# Access Compliance Report

## Public Rights-of-Way

Intersection ID: 10020112	Main Street: ASHLYN_CHASE_CT	Cross Street: N/A	Location: SE
ADA ID: EC34B3E7FBDC	Ramp Type: Perp	Initial Pass/Fail: Fail	Overall Compliance: No
Severity Score: 12.5			
Codes/Mitigation Info/Possible Solution		Field Measurements/Component Compliance

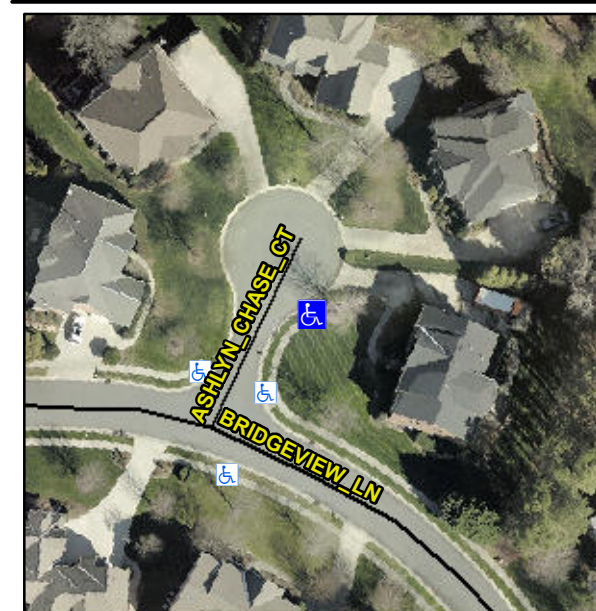
**Not Found, R304.2.2**

Compliance	Description	Data	Compliance	Description	Data
N/A	Ramp Length (in)	46.0	No	Ramp Slope (%)	10.4
Yes	Ramp Width (in)	53.0	Yes	Ramp XSlope (%)	1.1
N/A	Flare Type LT	N/A	N/A	Flare Type RT	N/A
N/A	Flare Slope LT (%)	N/A	N/A	Flare Slope RT (%)	N/A
N/A	Flare Traversable LT?	N/A	N/A	Flare Traversable RT?	N/A
N/A	Landing Length (in)	N/A	N/A	DWS Provided?	N/A
N/A	Landing Width (in)	N/A	N/A	DWS Contrast?	N/A
N/A	Landing Slope (%)	N/A	N/A	DWS Length (in)	N/A
N/A	Landing X Slope (%)	N/A	N/A	DWS Full Width?	N/A
N/A	Landing Curb? (Y/N)	N/A	N/A	DWS Offset (in)	N/A
N/A	Shared Landing?	N/A			
N/A	Gutter Ponding?	N/A	N/A	Gutter Slope (%)	N/A
N/A	Gutter Lip Ht (in)	N/A	N/A	Gutter X Slope (%)	1.0
N/A	Painted X Walk1?	No	N/A	Painted X Walk2?	N/A
	X Walk 1 Direction	To W		X Walk 2 Direction	N/A
N/A	X Walk 1 Width (in)	N/A	N/A	X Walk 2 Width (in)	N/A
	X Walk 1 Slope (%)	2.9		X Walk 2 Slope (%)	N/A
	X Walk 1 X Slope (%)	1.0		X Walk 2 X Slope (%)	N/A

**Remove & Replace Entire Ramp.**
